EXHIBIT B

Revision No. 1 to License Amendment Request Dated August 14, 1987

Docket No. 50-263

Exhibit B consists of marked up pages of the Monticello Technical Specifications showing the proposed changes as listed below:

FIGURE 6.1.21 MONTICELLO NUCLEAR GENERATING PLANT FUNCTIONAL ORGANIZATION FOR ON-SITE OPERATING GROUP

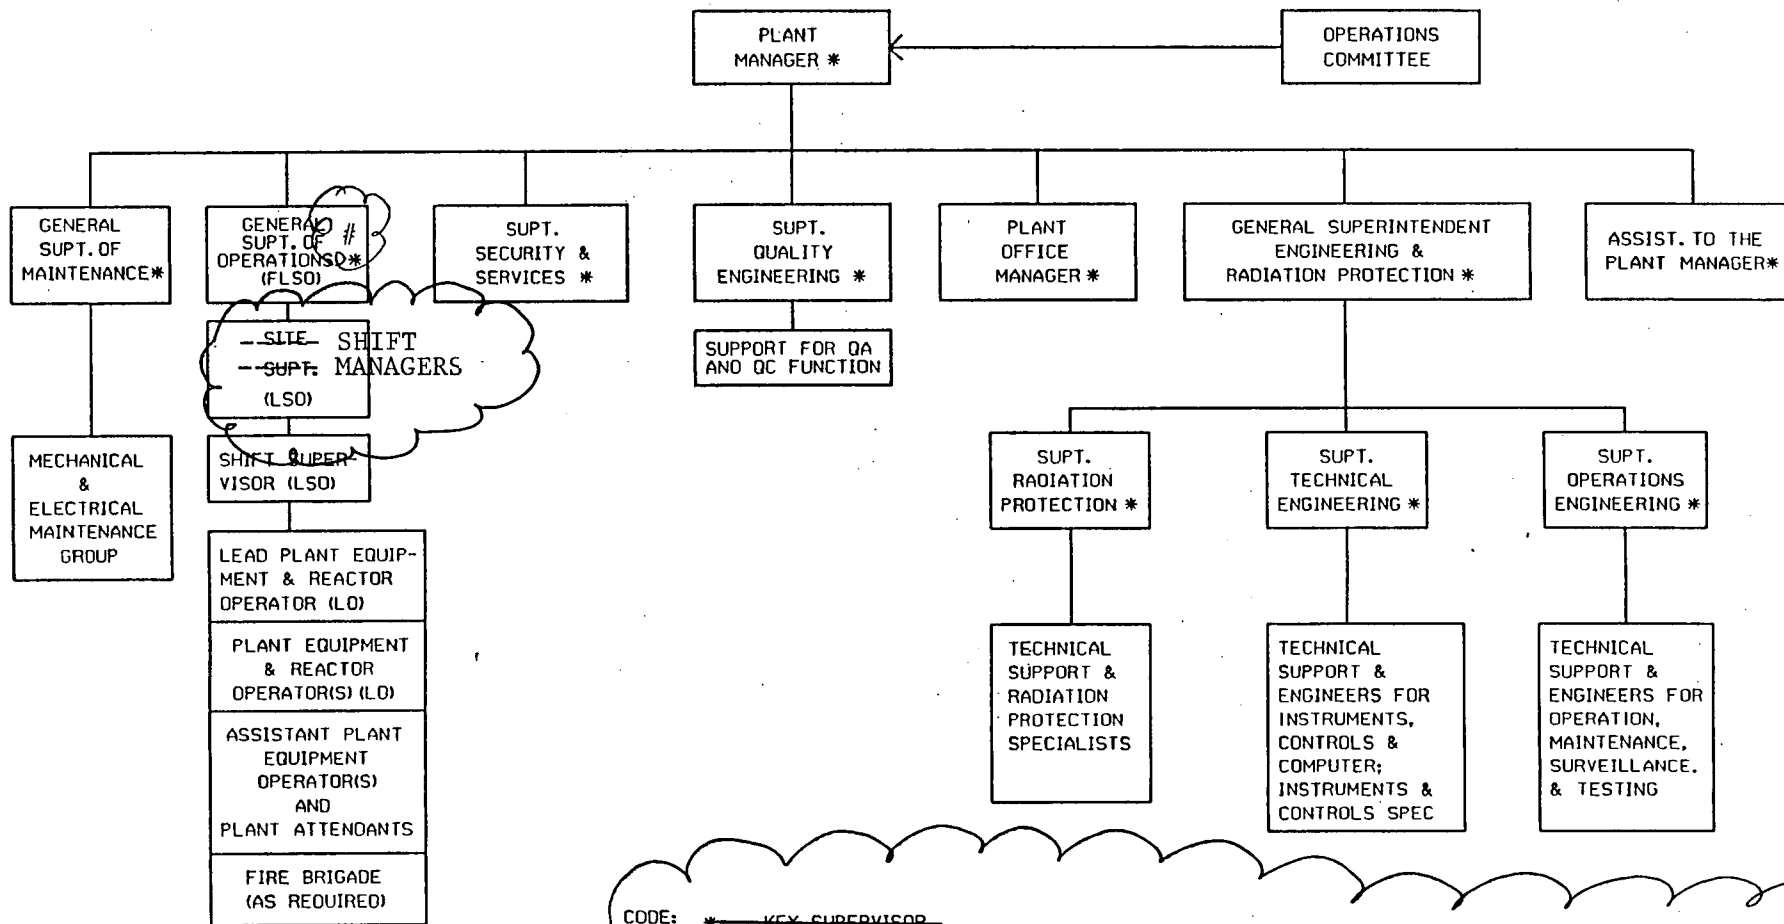
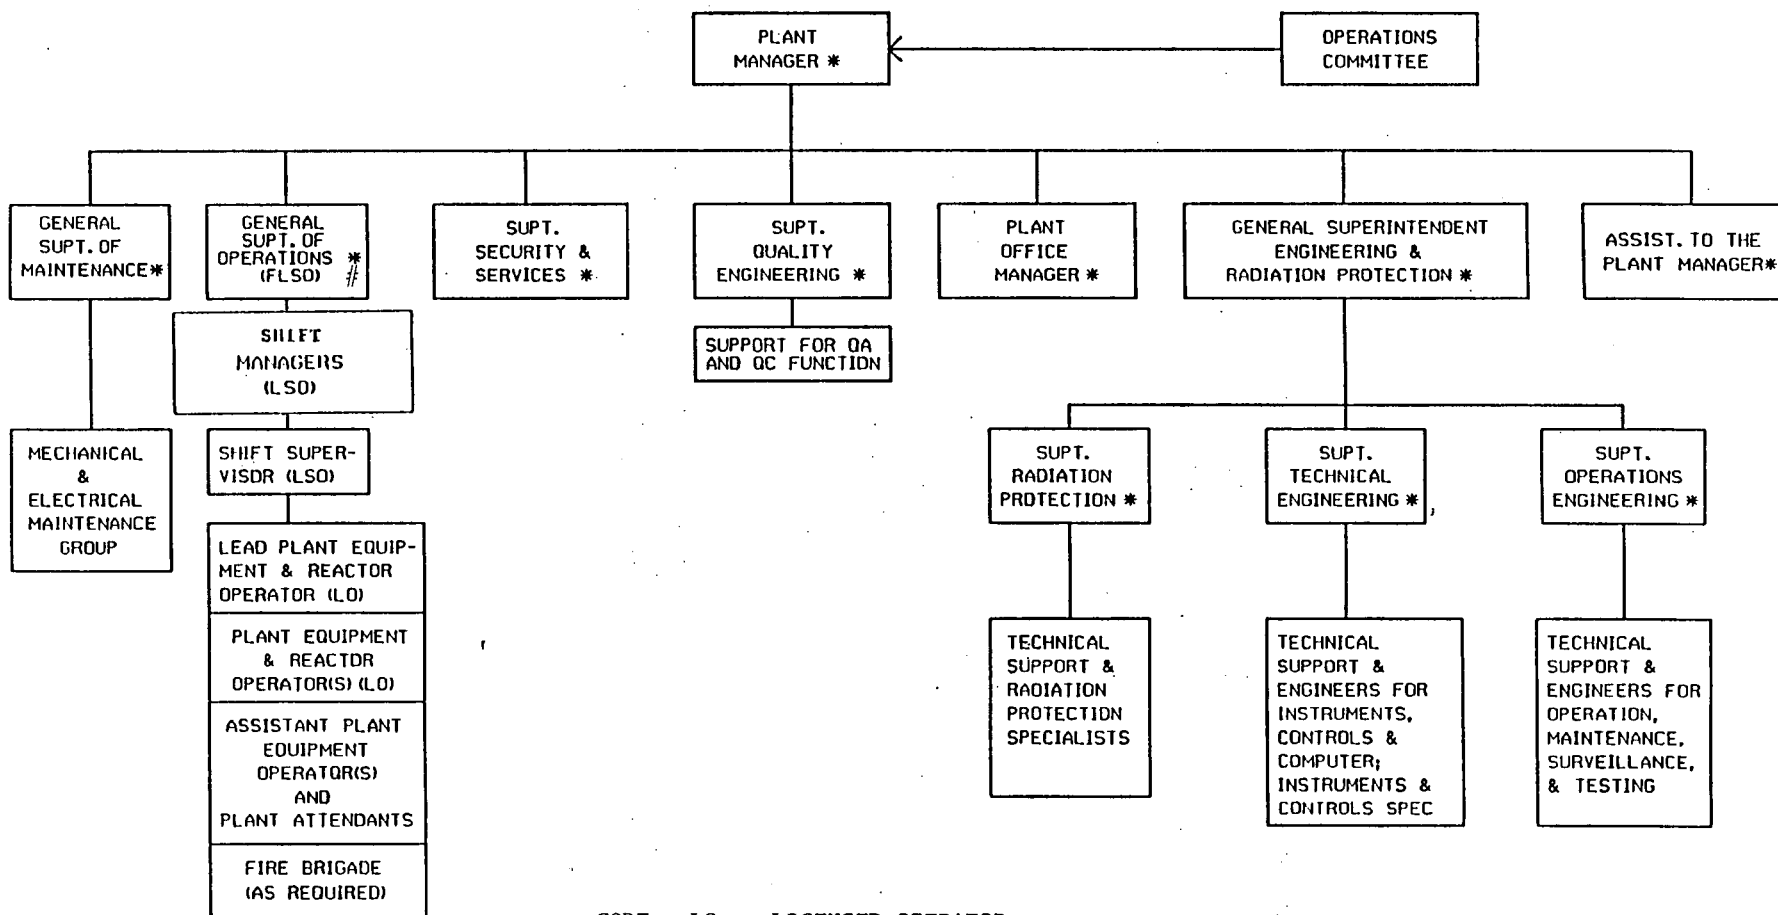
and (3) the General Superintendent of Operations who shall meet the requirements of ANSI N18.1 - 1971, except that NRC license requirements are as specified in FIGURE 6.1.2.

CODE: * ~~KEY SUPERVISOR~~
 LO LICENSED OPERATOR
 LSO LICENSED SENIOR OPERATOR
 FSLO FORMERLY LICENSED SENIOR OPERATOR OR LICENSED SENIOR OPERATOR
 * KEY SUPERVISOR
 # THE OPERATIONS GROUP WILL HAVE AT LEAST ONE MANAGEMENT INDIVIDUAL WHO HOLDS A SENIOR LICENSE WHO IS NOT ASSIGNED TO A ROTATING SHIFT

- D. Each member of the unit staff shall meet or exceed the minimum qualifications of ANSI N18.1-1971 for comparable positions, except for (1) the Superintendent Radiation Protection who shall meet or exceed the qualifications of Regulatory Guide 1.8, September 1975, (2) the Shift Technical Advisor who shall have a bachelor's degree or equivalent in a scientific or engineering discipline with specific training in plant design, and response and analysis of the plant for transients and accidents, and (3) the General Superintendent of Operations who shall meet the requirements of ANSI N18.1-1971, except that NRC license requirements are as specified in FIGURE 6.1.2.

CODE: LO LICENSED OPERATOR
 LSO LICENSED SENIOR OPERATOR
 FLSO FORMERLY LICENSED SENIOR OPERATOR OR LICENSED SENIOR OPERATOR
 * KEY SUPERVISOR
 # THE OPERATION GROUP WILL HAVE AT LEAST ONE MANAGEMENT INDIVIDUAL WHO HOLDS A SENIOR LICENSE WHO IS NOT ASSIGNED TO A ROTATING SHIFT
